PRODUCT UPDATE

Height Control Valve Kits

LIT NO: P56042

DATE: October 2017

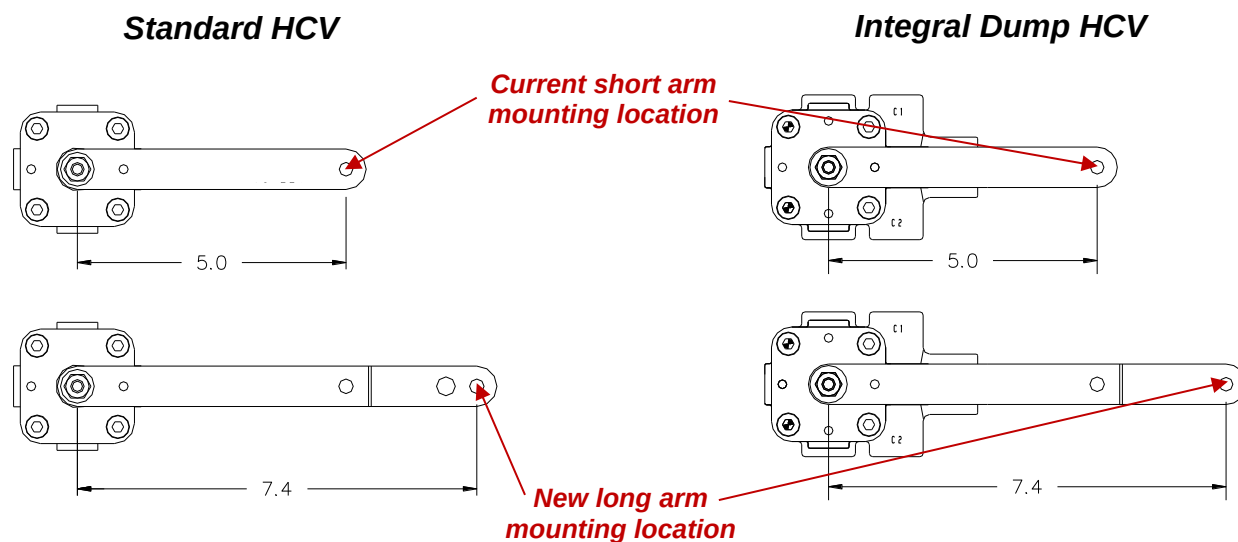
Effective mid-October 2017, the height control valve in the following kits will no longer have a short control arm. Instead, the valve will now have a long control arm. Please note, the link assembly should be attached to the hole closest to the end of the control arm (*shown below*). This change is designed to eliminate the possibility of the arm flipping when the suspensions are placed in full rebound, such as when a trailer is lifted completely off the ground. The function of the HCV does not change and therefore, HCV kit part numbers will not change.
